**City Council, Standing Committee and Commission
Conseil, comités permanents et commission**

Report / Agenda: ACS2025-PDB-PS-0020 / 7

Re: Amendments to Supporting Documents 2, 3 and 4

Appendix to Document 2 – Staff-Recommended Changes to Correct Errors in the Final Draft of the Zoning By-law

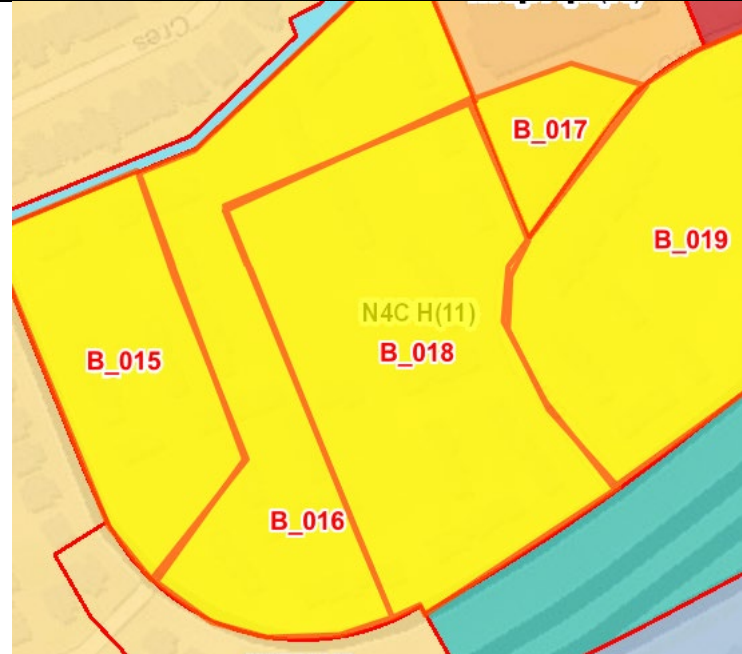
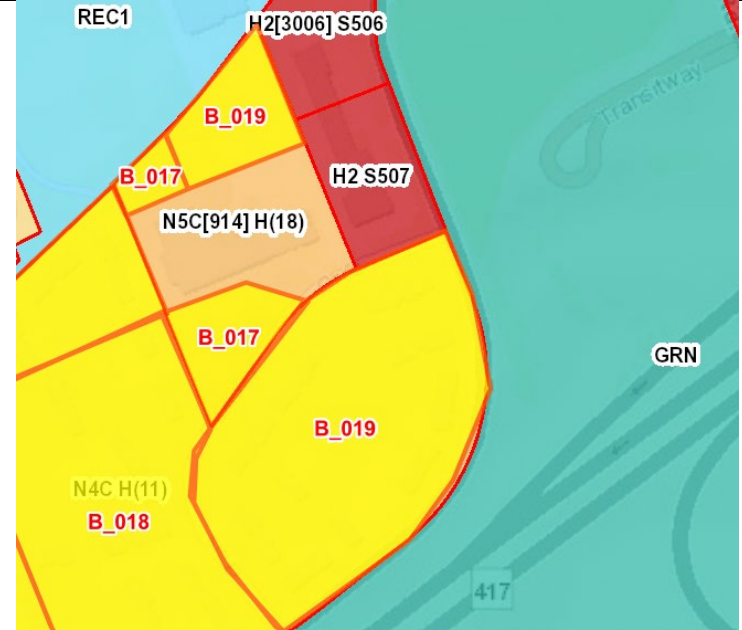
| Change of Intent (B Code) | | | | |
|---------------------------|-----------------------------------|--------------------------------|--|---|
| B_003 | 2090 Carp Road | Change zoning from RU to DR. | This parcel is inside the Urban Boundary, but not subject to the Future Neighbourhoods Overlay. It is currently uDR – Development Reserve Zone developed. DR maintains comparable permissions as the RU zone, but is more appropriate for undeveloped lands that are designated N in the Official Plan neighbourhood. |  |
| B_004 | 905, 927, 941 and 1035 March Road | Change zoning from RU to DR1 | These four parcels are currently Rural Countryside zoned RU, but are within the urban boundary. The Community Design Plan for the Kanata North Urban Expansion Area directs that undeveloped parcels be subject to Zoning Amendments. Development Reserve subzone 1 amendments. DR1 will recognize the existing dwellings here, while maintaining similar permissions as the RU zone and does not require existing dwellings to be accessory to another use. |  |

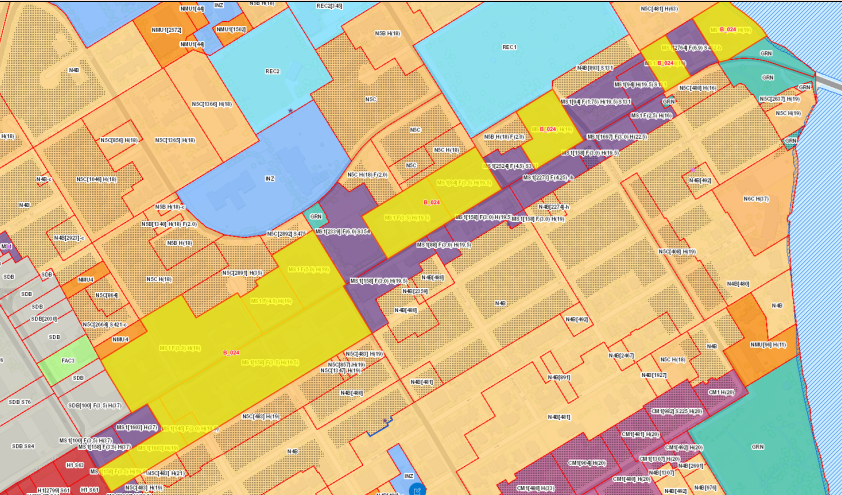
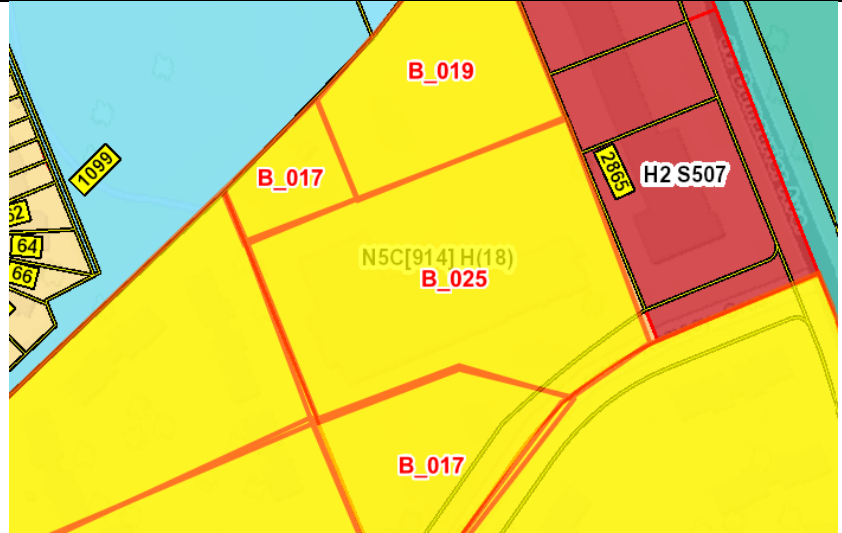
| Change of Intent (B Code) | | | | |
|------------------------------------|--|-----------------------------------|--|----------------------------|
| B_005 | 1145 Old Carp Road and parcel in between 905 and 927 Carp Road with no municipal address | Change zoning from RU to DR | These two parcels are currently zoned RU, but are within the urban boundary. The Community Design Plan for the Kanata North Urban Expansion Area directs that undeveloped parcels be subject to Zoamendments. Amendments. DR maintains comparable permissions as the RU zone, but is more appropriate for undeveloped lands within the urban boundary. | |
